HAMPTON ROADS THIRD HARBOR CROSSING

Technical Memorandum No. 2:

DESIGN BASIS MEMORANDUM

**March 2003
(Revised July 2003)**

Figure 1
Candidate Build Alternative 9

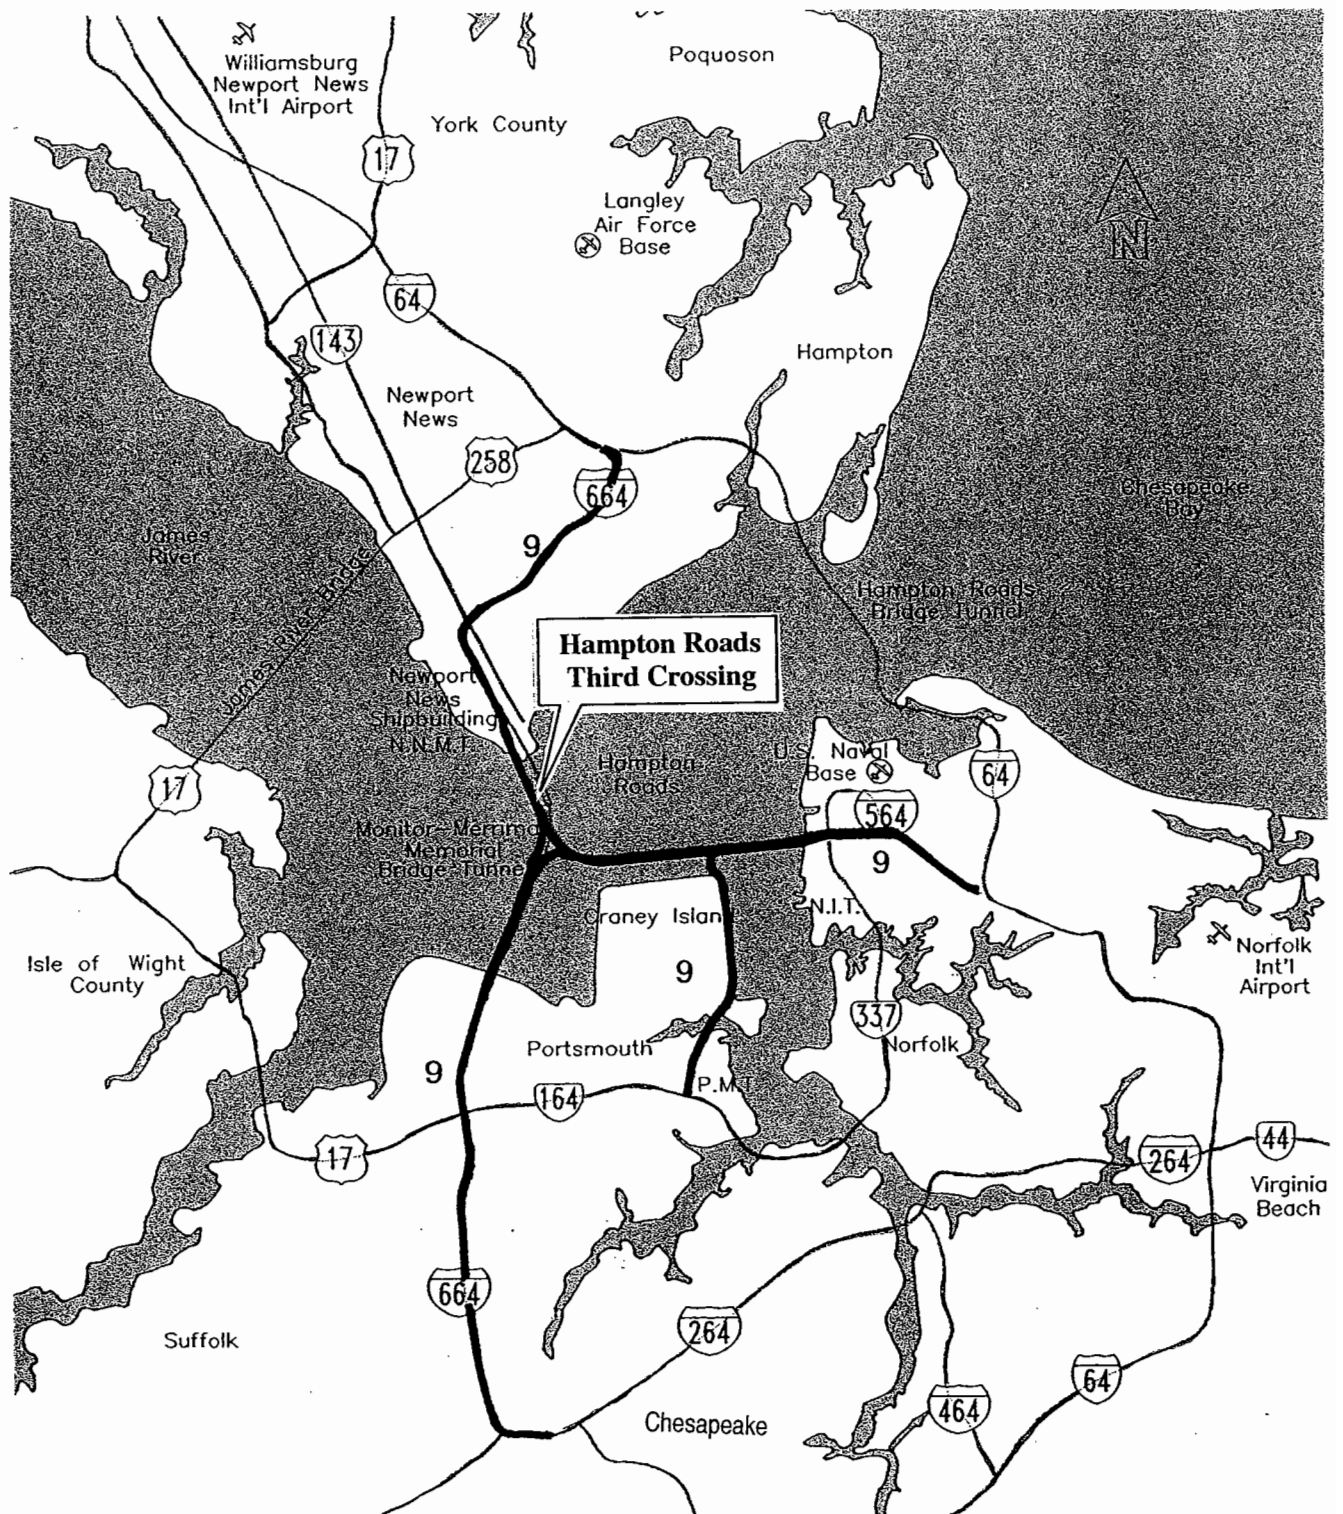
Document		
No.	Location	Comment
1.	Figure 1	Chesapeake is not shown on the map.
Response: Maps and drawings associated with the project and area show Chesapeake labeled as below the I-64 loop. Chesapeake will be shown on Fig 1.
